APPEAL SUMMARY

Appeal ID: 24405	Project Address: 4908 NE Tillamook St
Hearing Date: 11/25/20	Appellant Name: Jeff Hayes
Case No.: B-007	Appellant Phone: 205-601-9107
Appeal Type: Building	Plans Examiner/Inspector: Sloan Shelton
Project Type: residential	Stories: 2 Occupancy: Family Construction Type: Residence
Building/Business Name:	Fire Sprinklers: No
Appeal Involves: Alteration of an existing structure	LUR or Permit Application No.: 20-106616-RS
Plan Submitted Option: pdf [File 1] [File 2]	Proposed use: Residence

Appeal item 1

① STAIR DETAIL 1/2" = 1'

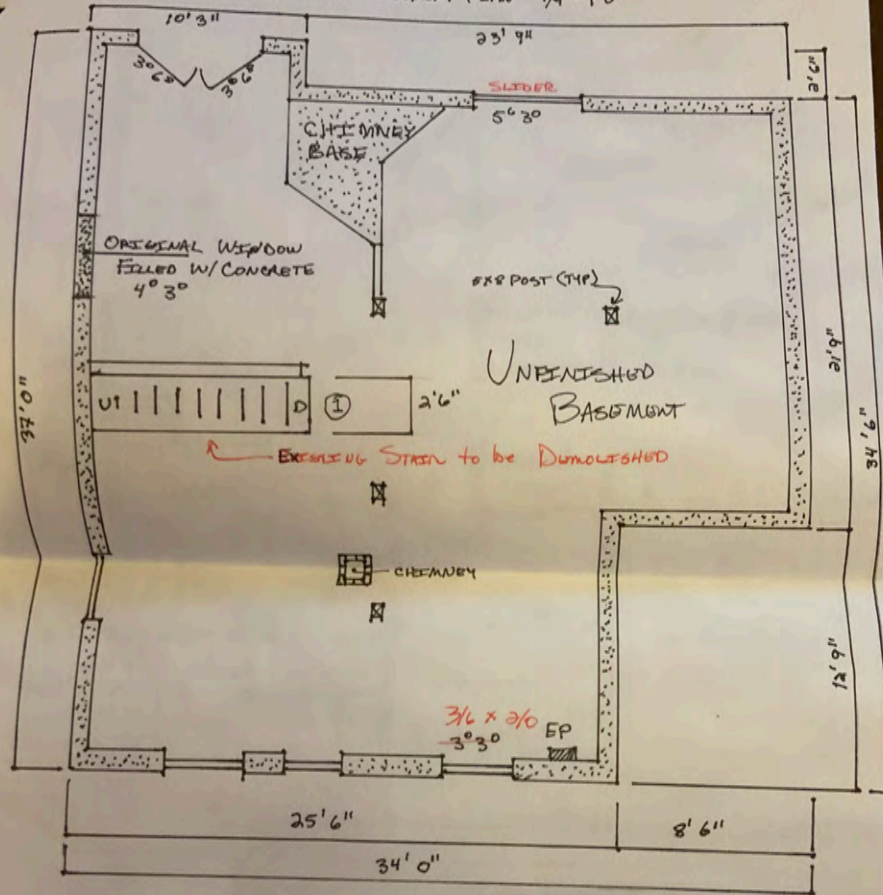
Code Section	R311.7 CG
Requires	<p>Existing stairs. Existing stairs may comply with the following:</p> <p>30" minimum width, 6'-2" headroom height measured vertically from the plane of the nosings of the treads.</p> <p>Maximum 9" rise and minimum 9" run, with no variation greater than 3/8" between risers or between treads.</p> <p>Existing triangular-shaped winder stairs are allowed</p> <p>New or replaced stairs must comply with current code requirements.</p>
Code Modification or Alternate Requested	I request that you approve the original basement stairs (built in 1914) rather than asking us to demolish and rebuild the stairs to match current code requirements.
Proposed Design	<p>After evaluating the complications with demolishing the original stairs from the first floor to the basement, which would require us also to demolish and rebuild the stairs from the first floor to the second floor as these sit right above the basement stairs, we did the following:</p> <p>We removed the original lathe and plaster walls and ceilings, giving us a width of 32" and a nominal ceiling height of 6'1"</p> <p>We put in a new subfloor and finished floor in the basement, all on one level for access to people with limited mobility (my daughter-in-law's parents), which raised the finished floor approximately 3 1/4" above the original concrete floor with asbestos tiles.</p> <p>We did not replace the carpet on the stairs to ensure maximum ceiling height.</p>

Reason for alternative	First, in my opinion a 6'1" nominal ceiling height is equivalent in terms of health, accessibility, structural capacity and energy conservation to rebuilt stairs with a 6'2" nominal ceiling height.

Second, given that the landing at the top of the basement stairs has an exit and that there is a double door exit within 16' of the base of the basement stairs, in my opinion the original stairs are equivalent in terms of life safety and fire protection to rebuilt stairs that would comply with current code requirements.

Third, the bottom tread is 5" above the new basement floor, which gives it a greater than 3/8" difference from the typical rise of the rest of the risers (8"), and it is 11 1/4" run, which gives it a greater than 3/8" difference from the typical run of the treads (9"). It is also 1 1/2" thick rather than 3/4" thick like the other treads. However, as this is the bottom step, in my opinion it provides a greater landing area for people going up or coming down the stairs. Yet if required, we could replace it with a tread that matches the others in thickness and run. In my opinion, this tread is preferable to the fix suggested by the inspectors: that we remove the bottom tread entirely and build a 3'x3' platform with a rise matching that of the other risers. Should we do this, we would have less than 36" of clear passage between the platform and a support post, limiting access for people with limited mobility.

1a. Decrease in minimum required headroom at existing stairs to basement conversion from 6' 8" to 6' 1": Denied. Proposal does not provide equivalent Life Safety protection.

1b. Reduction in minimum required riser height from 8" to 3": Denied. Proposal does not provide equivalent Life Safety protection.
